## WCHS Phase 1: Change Order #012 Summary

Tier 1 Project: New Woodford Co High School-Phase I

DATE:	11/07/2024	PR #:	PR 073
TO:	Clay Ratliff – Trace Creek Construction Mike Grayson – Trace Creek Construction	RE:	Woodford County Board of Education Versailles, Kentucky BG 19-353 RTA 1916

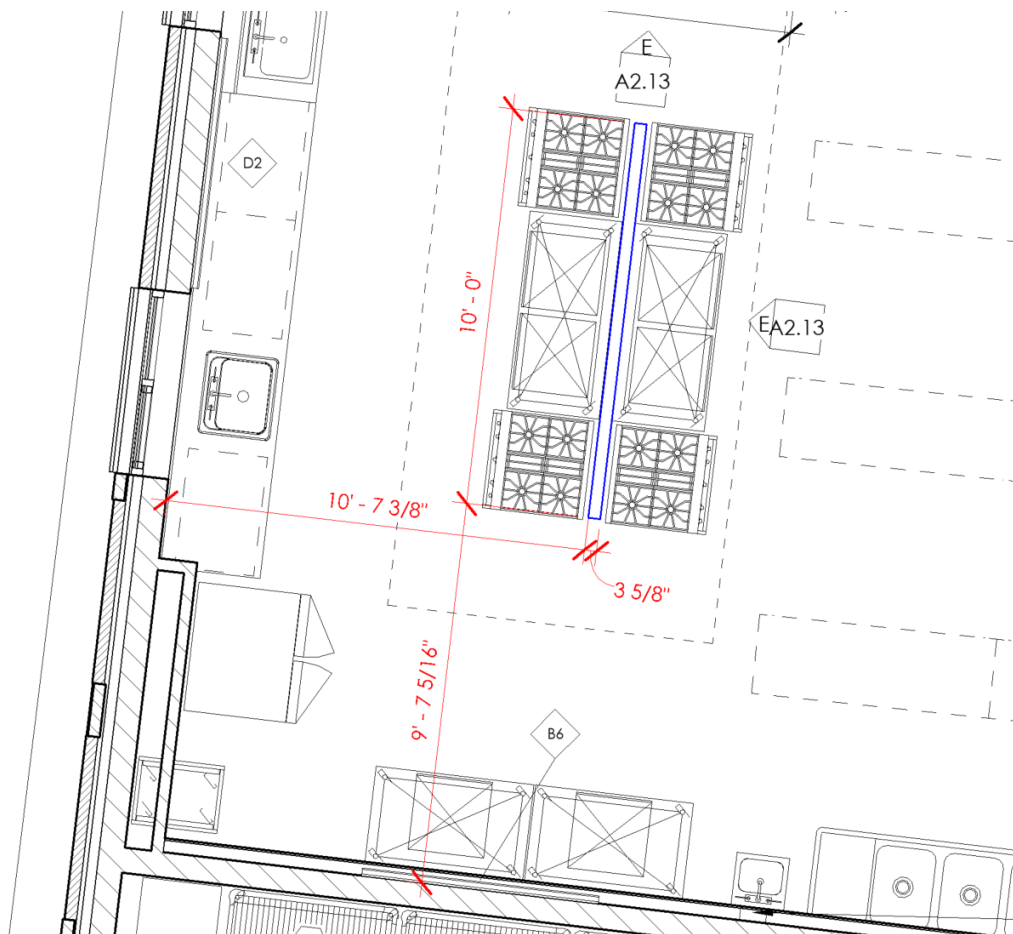
1. Provide pricing for knee wall at culinary 148, refer to detail E/A2.13.

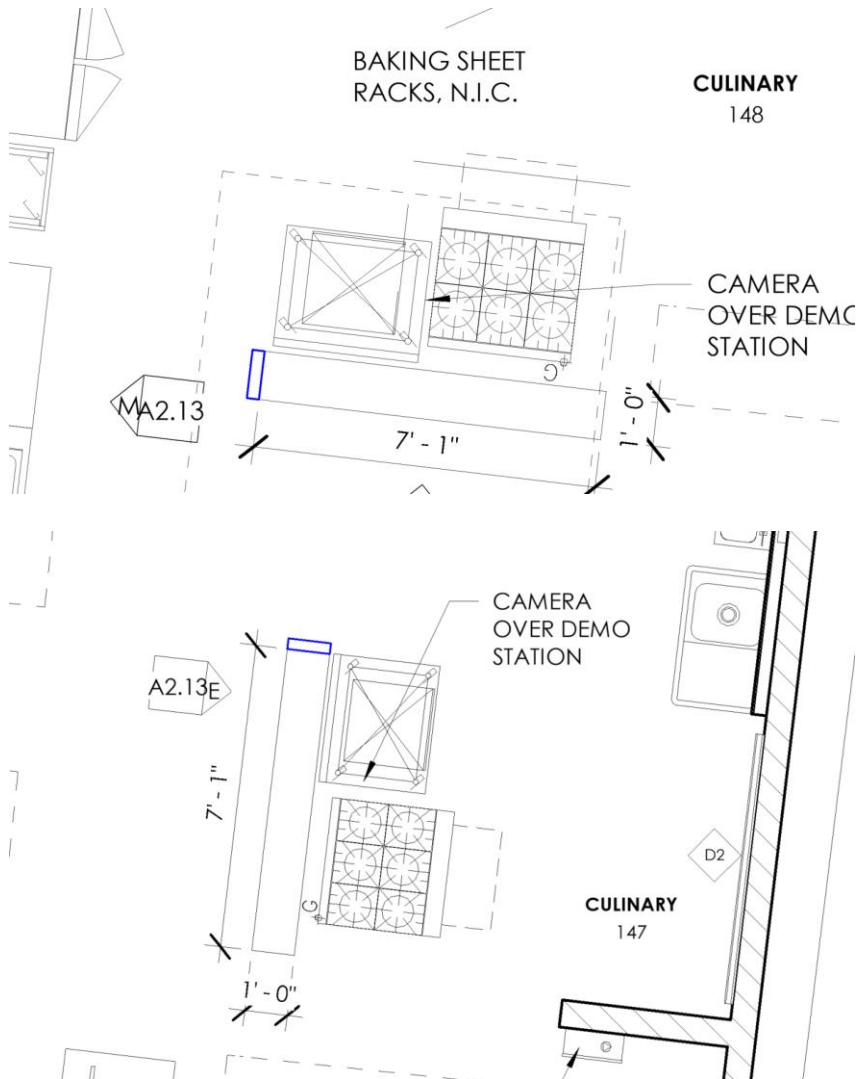
2. Provide pricing for 2 stainless steel chases, floor to ceiling in height, in the locations below. Field verify chase size for gas line requirements.

A knee wall was needed for gas piping to travel through at Culinary 148. (2) additional stainless steel chases were needed at Culinary 148 and Culinary 149 for gas piping to travel to stoves.
